Metropolitan Development Commission Regional Center Hearing Examiner (August 15, 2024) Meeting Agenda

STAFF REPORT

Case Number	2024-REG-032
Address (approx.)	817-831 Charles Street (odd) and 826-840 Union Street (even)
Location	Center Township, Council District #18
Petitioner	Honor Investments LLC, by Russell L. Brown
Zoning	CBD-2 (RC)
Request	Regional Center Approval to provide for the construction of 16 townhomes within four, four-story buildings, with attached garages.

Case Number	2024-REG-041
Address (approx.)	40 South Alabama Street
Location	Center Township, Council District # 18
Petitioner	City of Indianapolis, by Steve Winters
Zoning	CBD-2 (RC)
Request	Regional Center Approval to provide for demolition of the former Marion County Jail 1 building.

Meridian Enclave - Buildings 1 & 2
WOVE
 ARCHITECTURE + DESIGN
 817.831.8100
 817.831.8100
 817.831.8100
SD205
 07.25.24

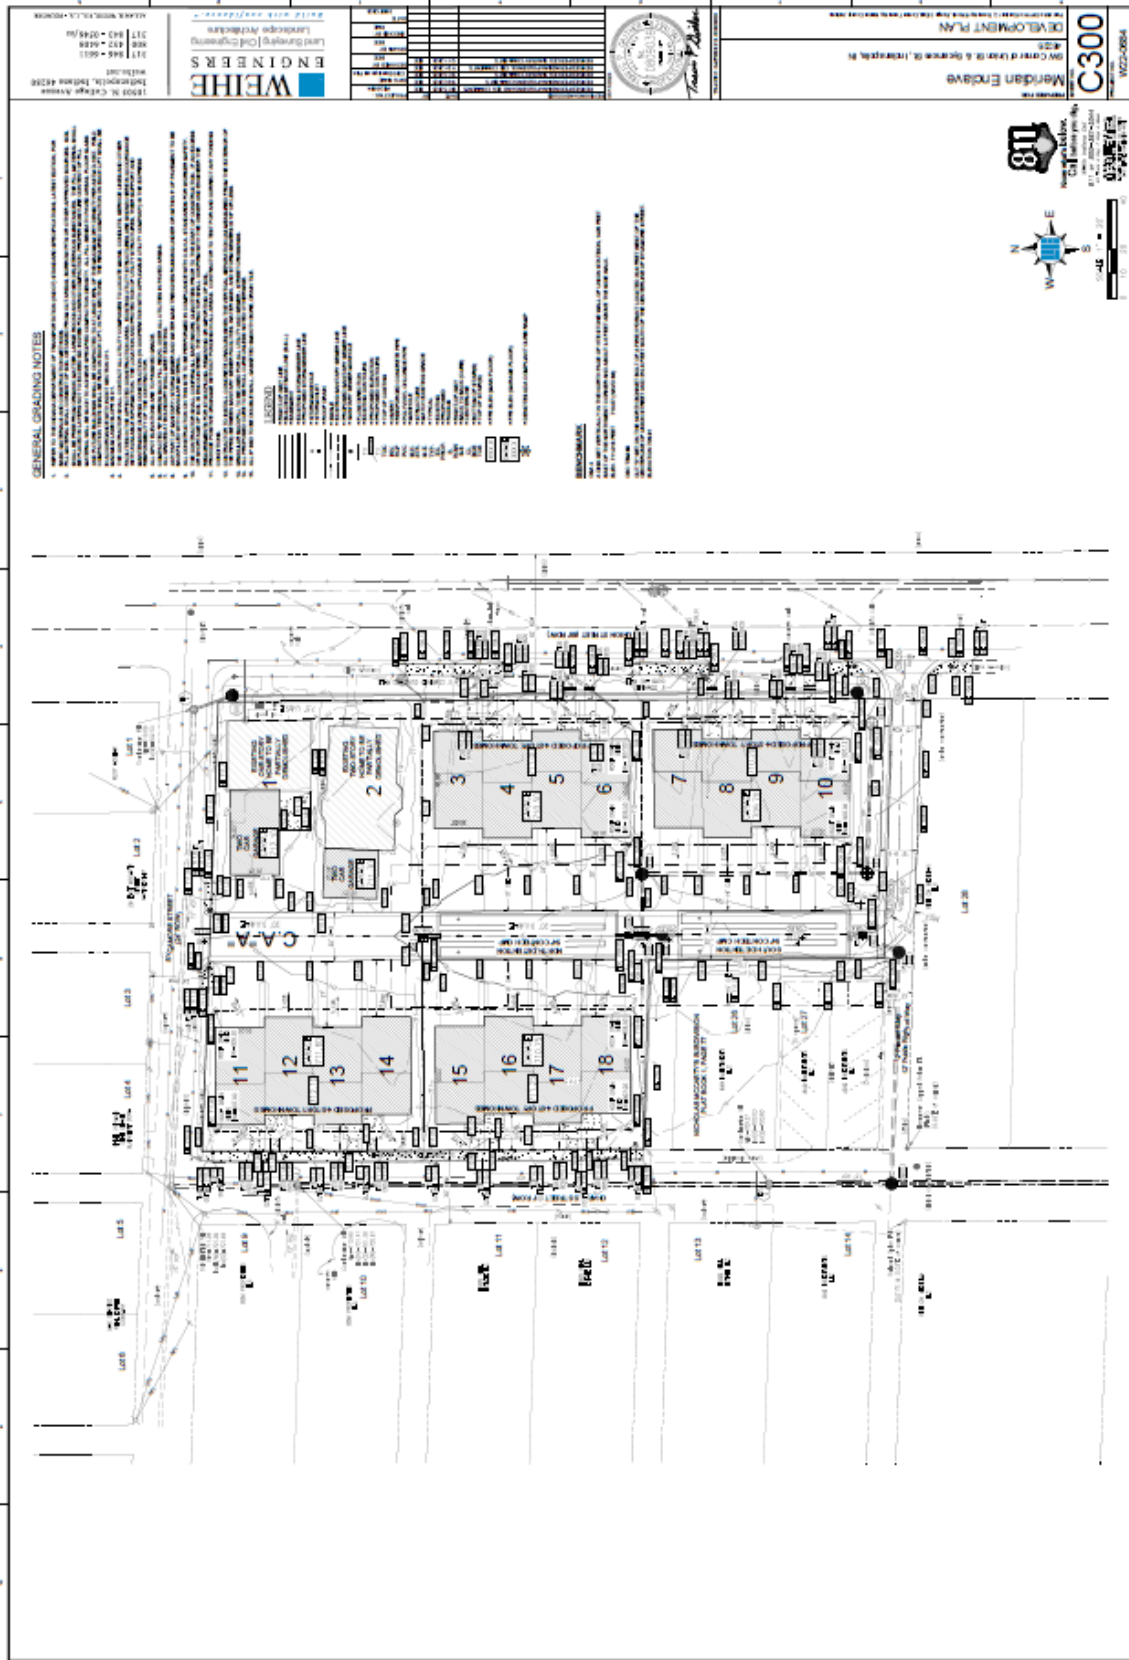
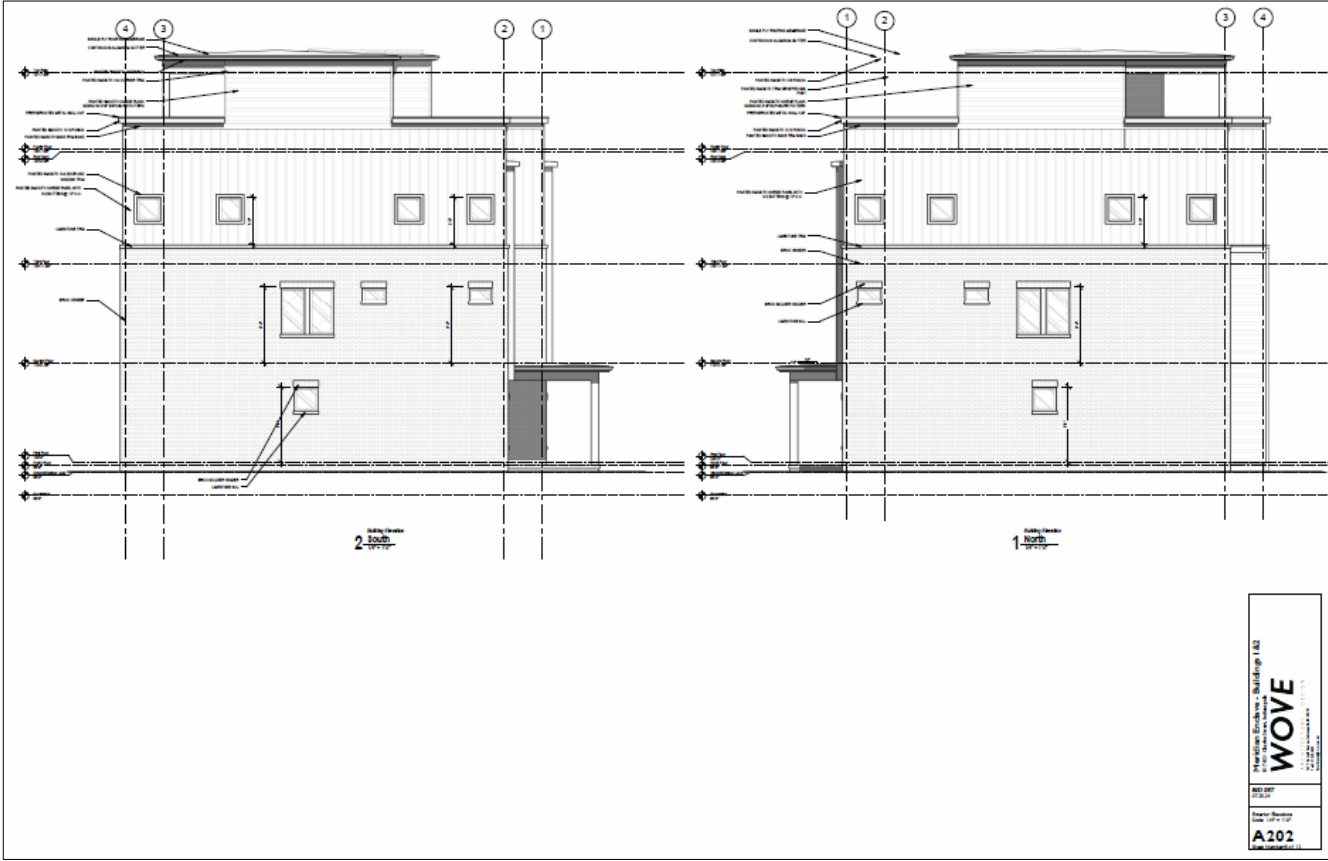
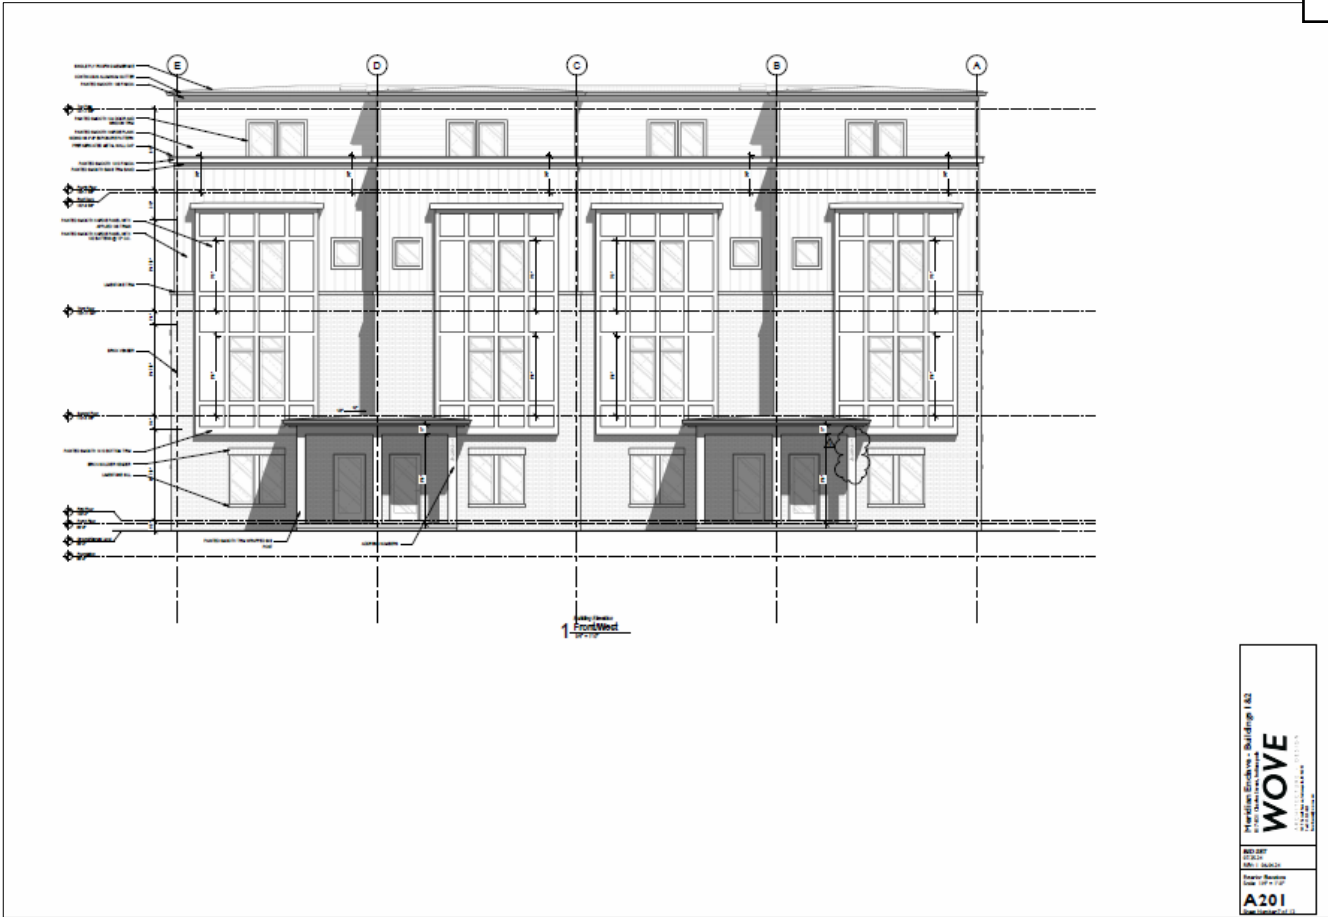
Review of the Guidelines against the submitted plans reveals a few items that remain outstanding or require explanation.

2. A photometric plan has not been submitted to the file. A photometric plan should detail light standards and photometric levels for the site and at each entrance. Lighting must be provided at each entrance and must be dusk to dawn. Only full cut and shielded light standards are permitted with minimum foot-candle power outlined in CA 4.3.2 and CA 4.3.3. Pedestrian areas and entries must be lighted for safety (CA 3.1.3 and CA 4.3.1). The lighting details shall be submitted and subject to planning staff review and approval, prior to the issuance of an Improvement Location Permit.
